Madera Unified School District

Addendum No.1 Bid No.031125-Thomas Jefferson MS Roofing Project

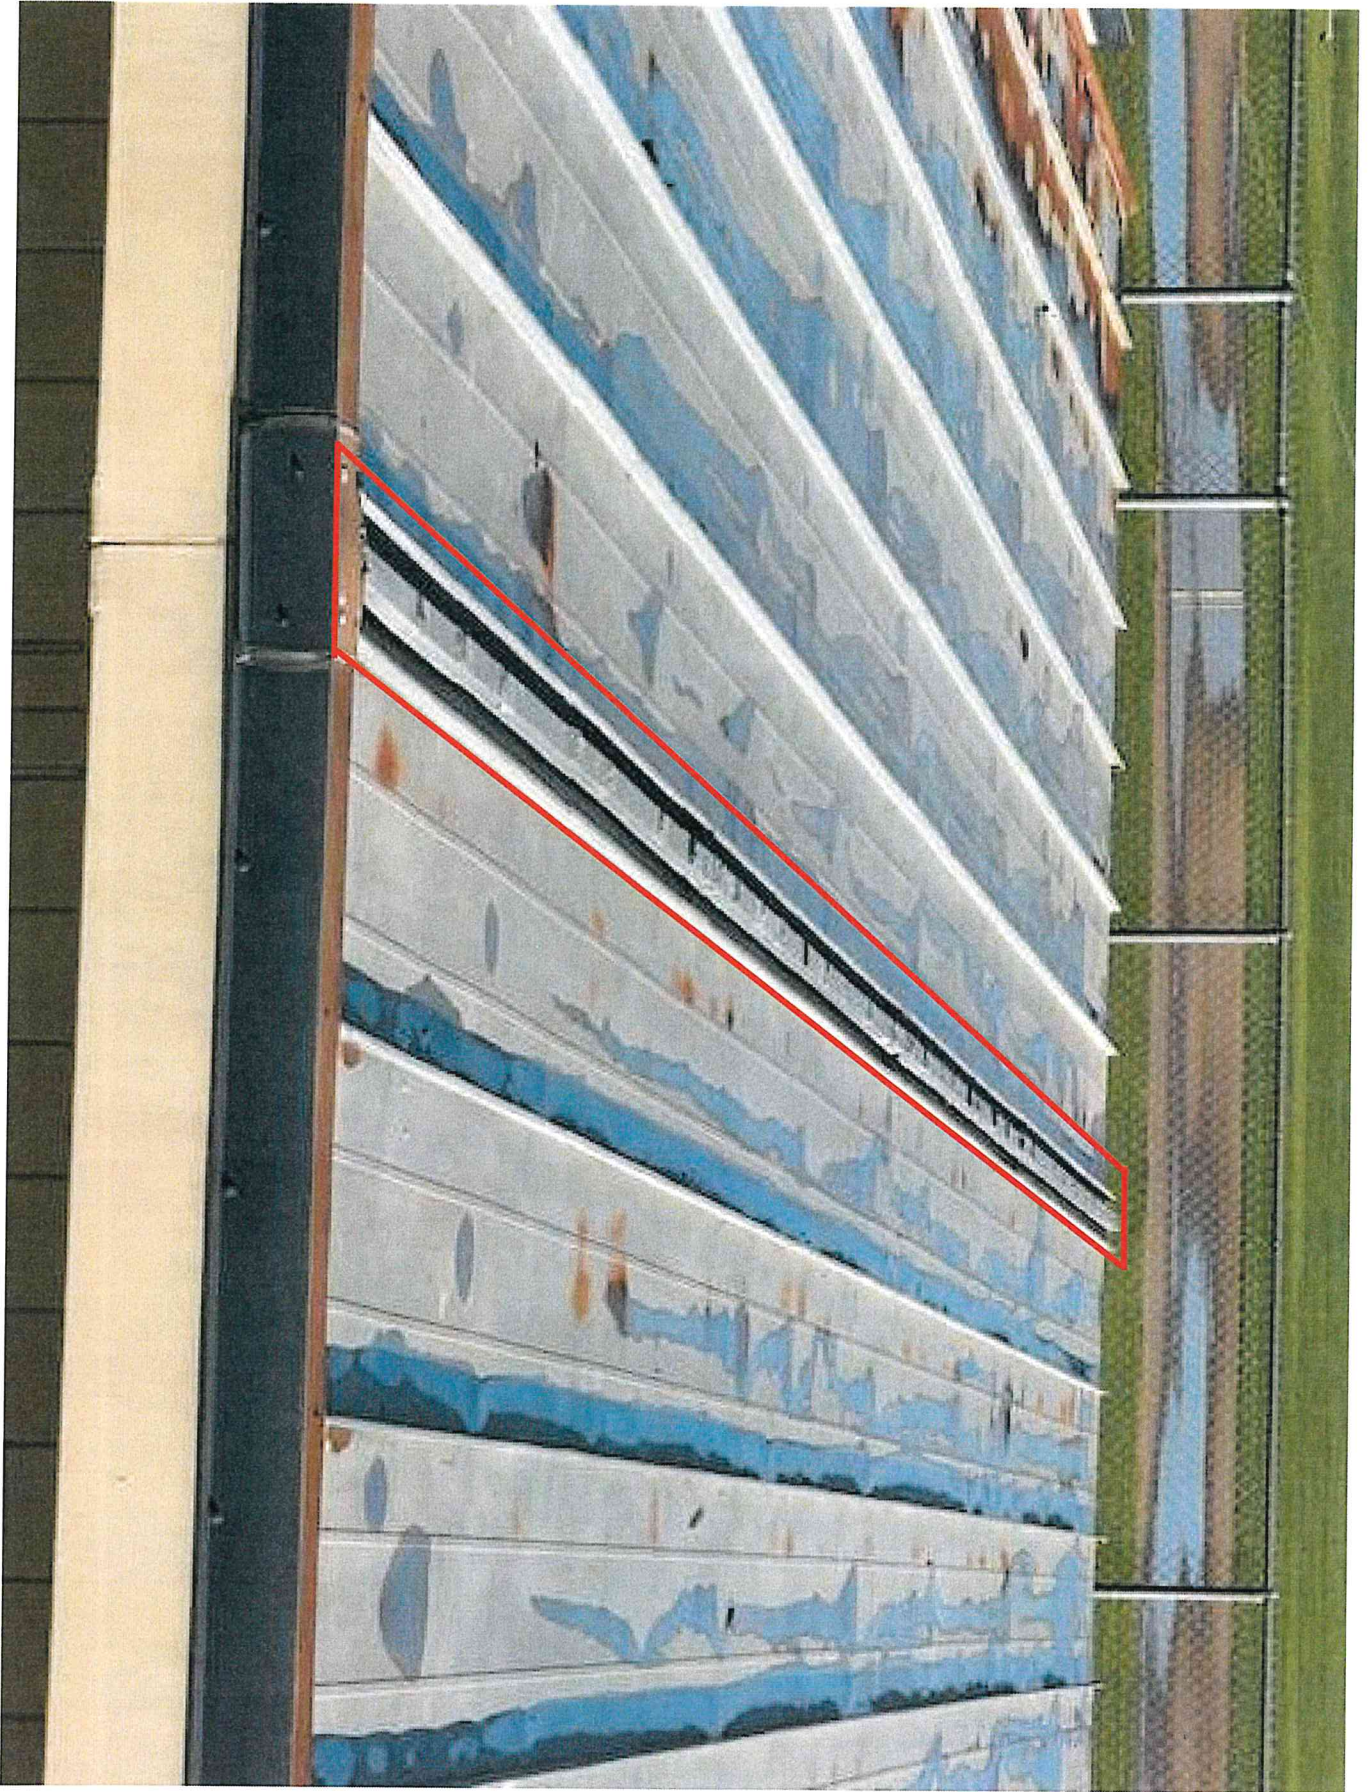
- Add to Section 011100 Summary of Work Section 1.3, D: Install new rubber dura blocks at all locations as needed. Existing dura blocks that are in good condition may be reused.
- Add to Section Section 011100 Summary of Work Section 1.3, D: see the attached site map and photos.
 - Install a 22 gauge galvanized sheet metal cap over the ridge line and fasten on each side. Classrooms 33-36
 - Change building "P", remove the original building P as shown and change to the addendum building P.
 - Repair blisters in the walkway roof as noted along the brick wall and shown on the site map.
See attached

Addendum 1 -
Install a 22 ga galvanized sheet metal cap
over the ridge line and fasten on each side.
Classrooms 33-36

Addendum 1 -
This building is not included.
Building P moved to upper top
right side of the site photo

Addendum 1 -
Repair all blisters in this roof area
as discussed at the pre bid meeting

Addendum 1 -
Add Change to Building P
Add to Scope of Work
